PROJECT MR SMITH - ROKEBY ST

DATE: 17 March 2020

APPLICATION NO: PLN19/0707

DESCRIPTION: Demolition of the existing building to allow for the development of the land

TITLE
3D PERSPECTIVE
ROKEBY ST
REVISED

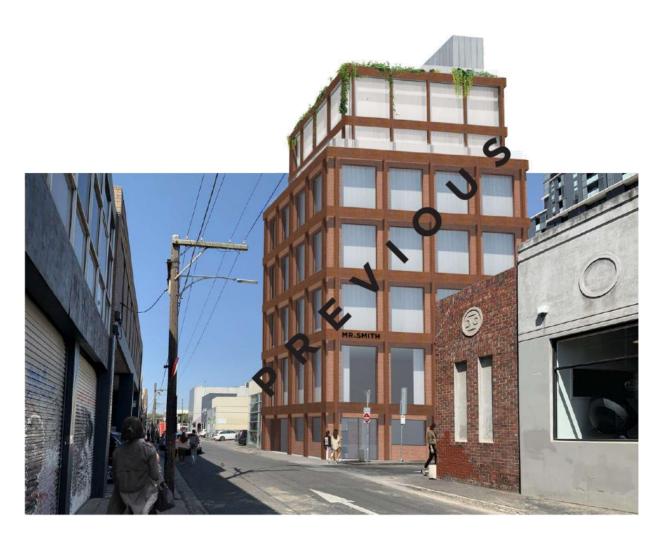
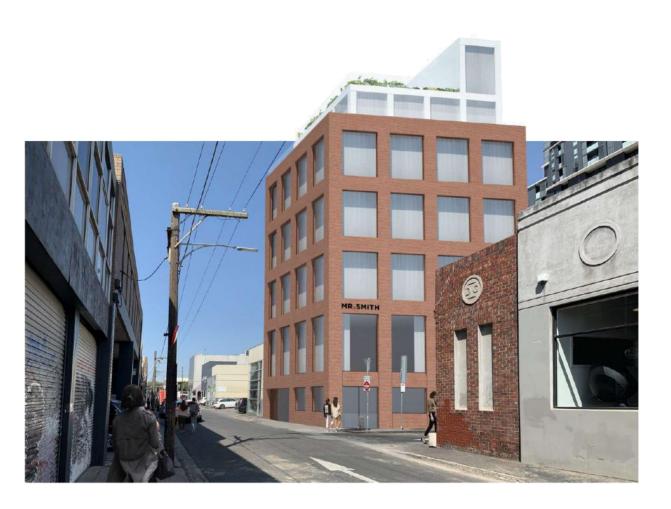
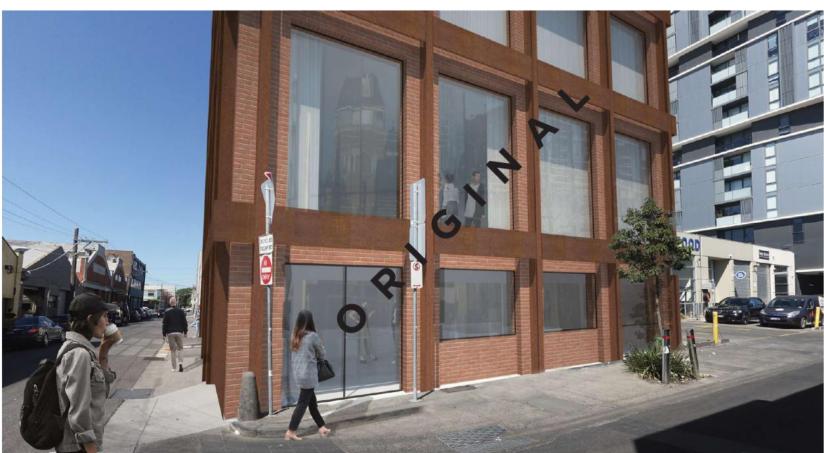
In terms of the Heritage comments, my clients are willing to remove the skeletal frame from the design. The image below shows it's deletion. This may also assist Council's UD comments given the lighter weight upper section of the building, noting the five (5) storey podium is consistent with the built form approved with No.89 Rokeby.

ROKEBY STREET ROAD FRONTAGE OF DEVELOPMENT

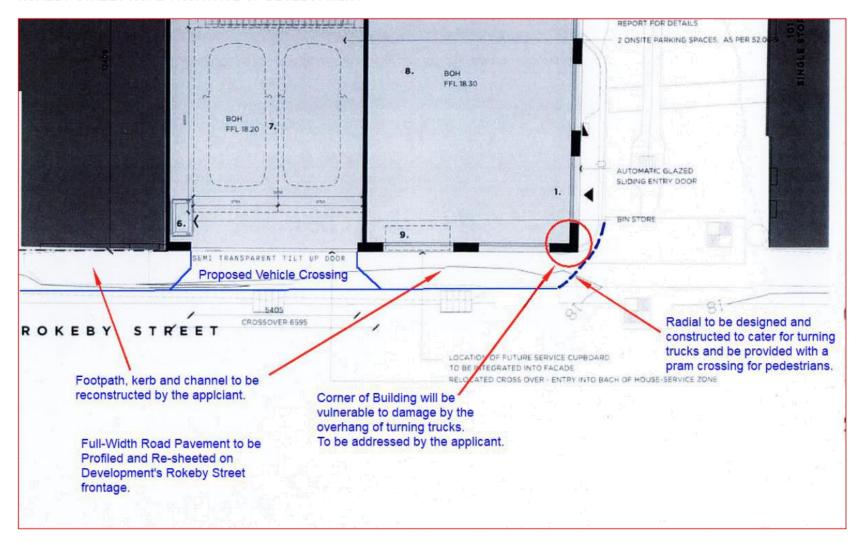
North East Corner of Building will be vulnerable to being damaged by overhang of turning trucks. Applicant needs to address this matter before the drawings are endorsed.

Vehicle Crossing - Cross Section

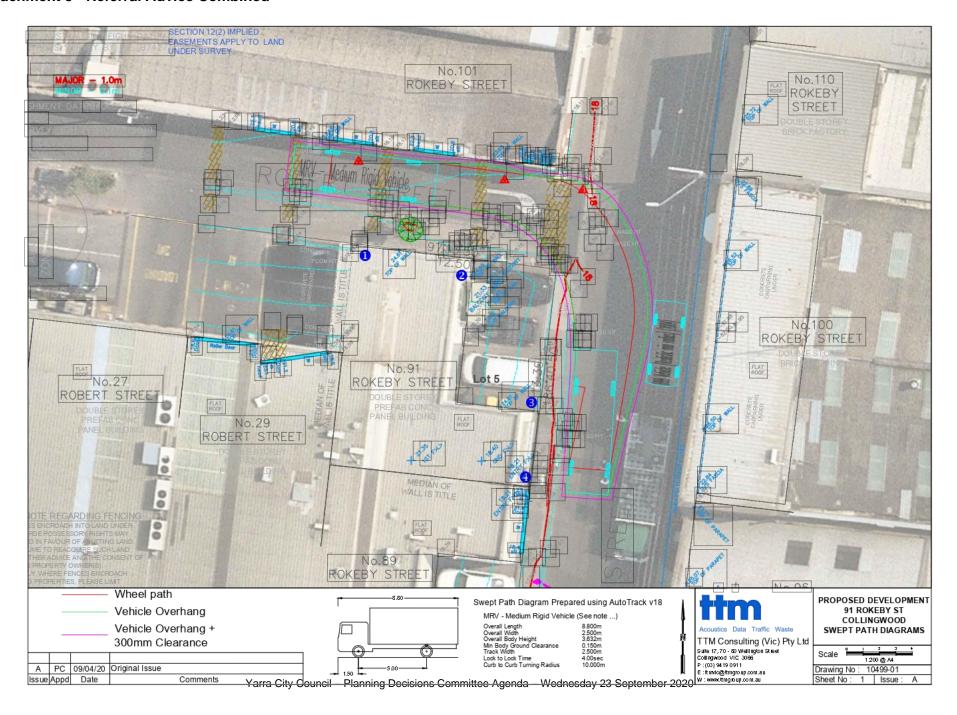
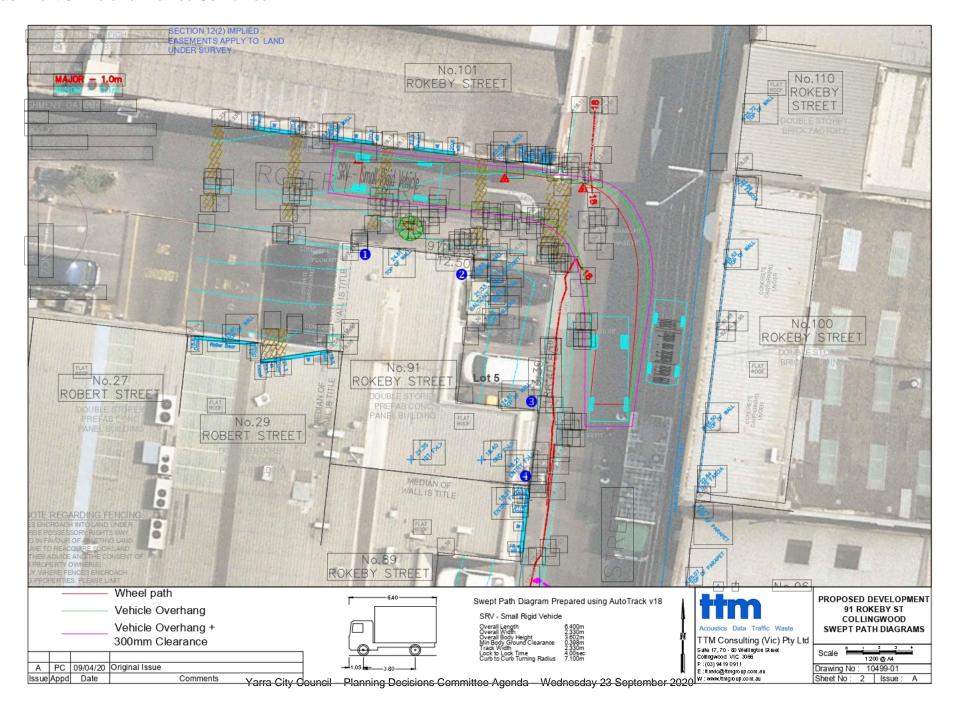
The designer is to submit a 1:20 scale cross section for each proposed vehicle crossing showing the following items:

- A. Finished floor level 2.0 metres inside property
- B. Property line surface level
- C. Surface level at change in grade (if applicable)
- D. Bullnose (max height 60mm) must be clearly labelled

- E. Surface level at the bottom of the kerb
- F. Surface level at the edge of channel
- G. Road level 1.0 meter from the edge of channel
- H., I. Road levels

- o Please note the cross section must be fully dimensioned. As shown in the sketch below.
- Please show both the existing and proposed surface.
- The maximum allowable cross-fall between points B and C is 1:40 (2.5%).
